INDIGO ACOUSTICS

Our Ref: 10-315A

RE: RESPONSE TO COMMENTS FROM COUNCIL re BUNNINGS STORE AT
SMITHFIELD

Appendix - Monitoring undertaken by Wilkinson Murray

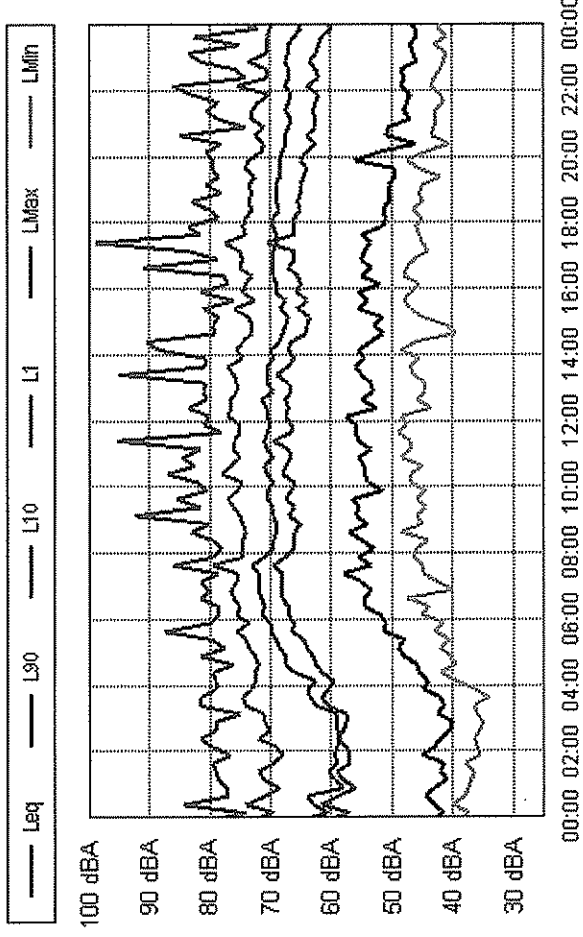
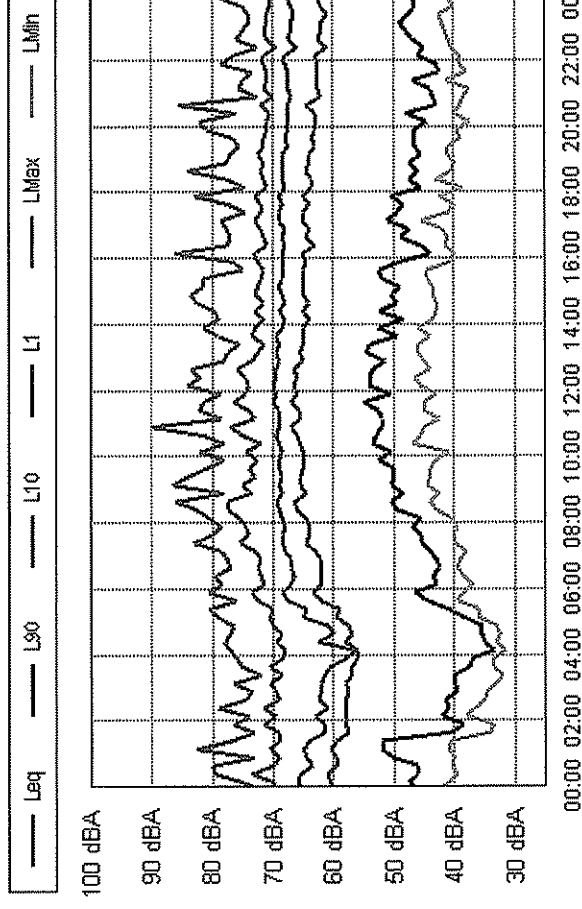
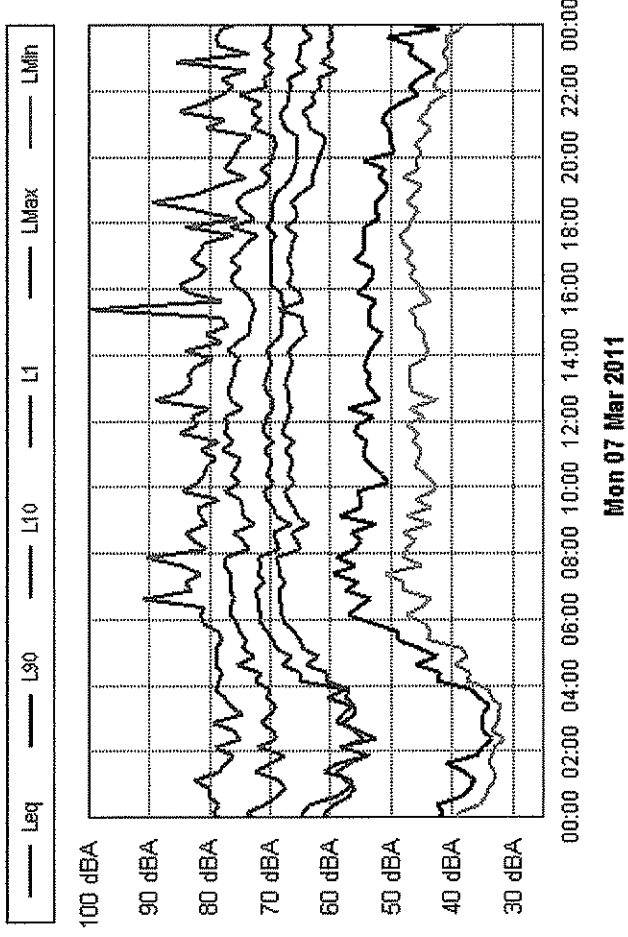
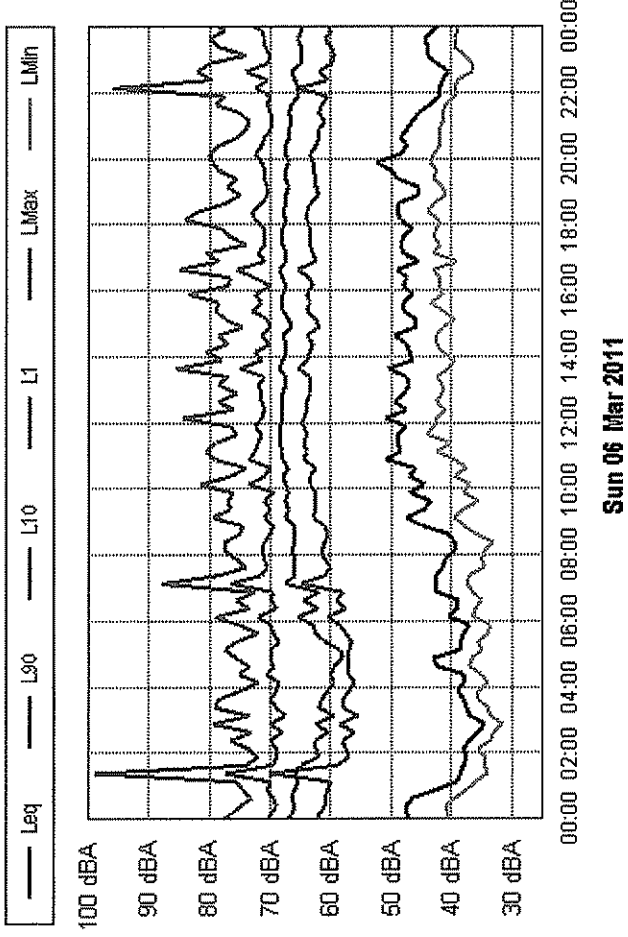
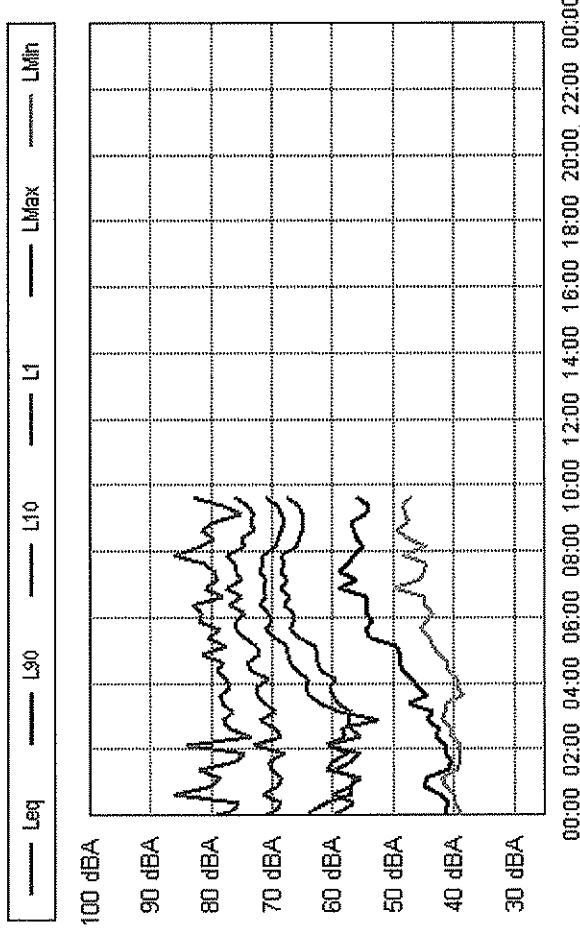
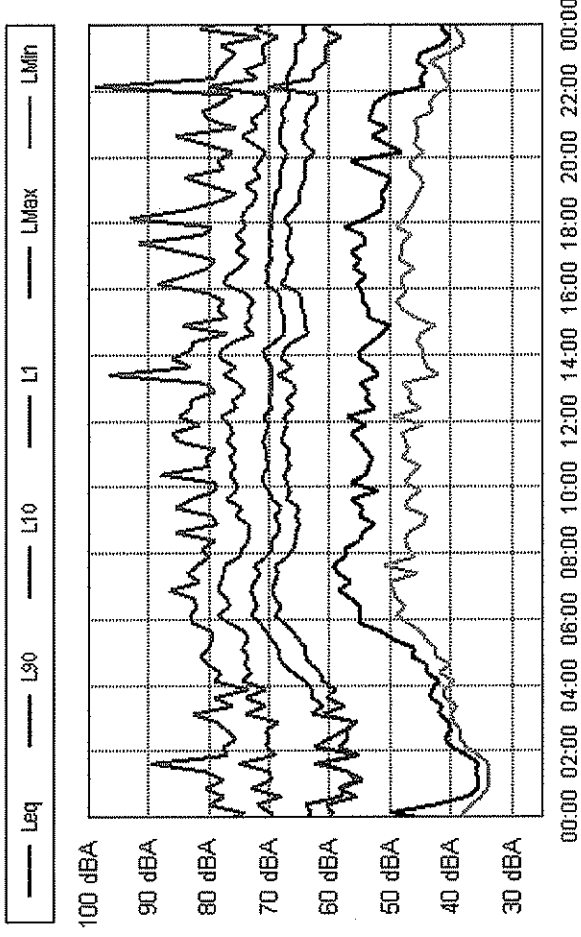
The period of noise monitoring undertaken in the above acoustic assessment was inadequate. Background monitoring shall be undertaken for a minimum seven (7) days (i.e. equivalent to one week's worth of valid data covering the days and times of operation) and in accordance with all other requirements of Section 3 of the INP.

Monitoring has now been undertaken between Wednesday 2 March and Wednesday 9 March 2011 in the front yard of 734 The Horsley Drive, the closest house to the proposed Bunnings store. The complete results are appended to this letter.
